Hose protection for hydraulic pressure pipe 9700 (B13R)

Safety Recall

SR12-65

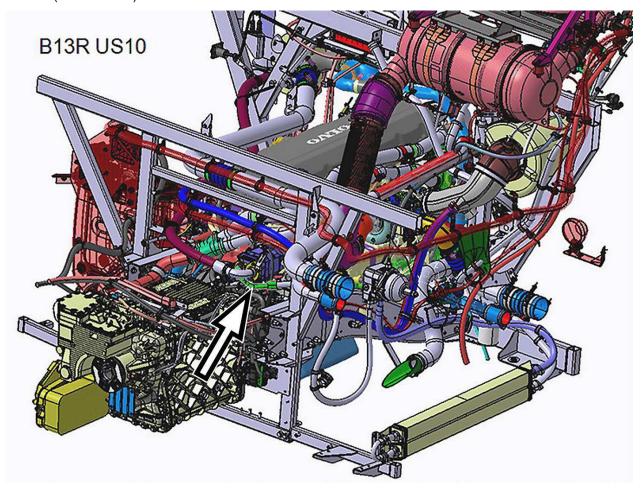
2. Locate the hydraulic pump and hydraulic pressure pipe. It is the smaller pipe with a test nipple. (US10 shown)

Hydraulic pressure pipe (US 07 shown)

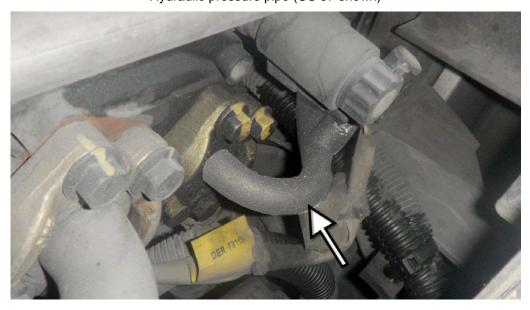
3. Fit the supplied protection hose on the pressure pipe/hose. Rubber protection hose shall cover the whole pipe, up to the connecting flange. Due to the tight bend of the pipe, the protection hose must exceed the pipe end to cover it 100%. (US 10 shown)

Use heat resistant (white) cable ties, p/n 70312532, to secure the protection hose. Make sure the protection hose slit cut is facing downwards when hose is installed on the pipe, thus preventing any risk of oil spray on hot components.
